P5023A-03A-S

Safety Service Note

P5023A Keysight Streamline USB Vector Network Analyzer

“POTENTIAL BURN INJURY (HIGH TEMPERATURE) HAZARD”

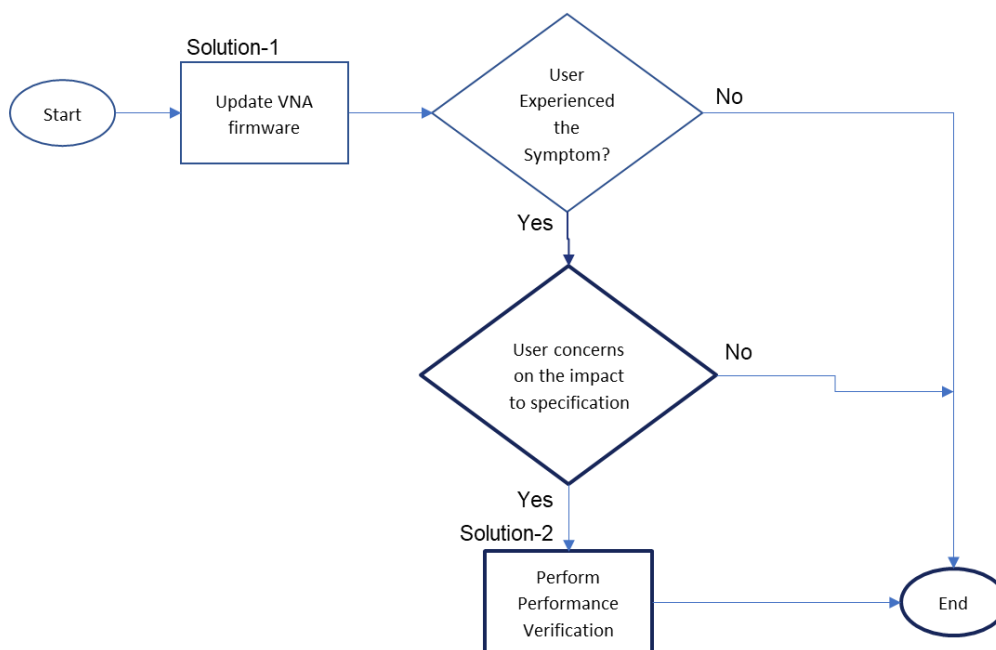
VNA fails to start with the following symptoms.

1. LED indicator (below circle) turns red.
2. cooling fan does not work
3. If user leaves the VNA with this LED indicator red without turning off power switch, it continues to overheat and becomes too hot.

Solution-1: Update VNA firmware by user

Action-1: Updating the firmware eliminates this potential risk of overheating.

1. **Install the latest VNA firmware Rev. A.15.55.14 or newer** on users' controller PC(s).
The latest firmware enhanced the thermal fan control mechanism.
2. Once the latest firmware is installed, proceed with the restart of both **controller PC** and **VNA**.
3. Launch the VNA firmware. Ensure VNA powers up and launches into firmware correctly after firmware update is done.
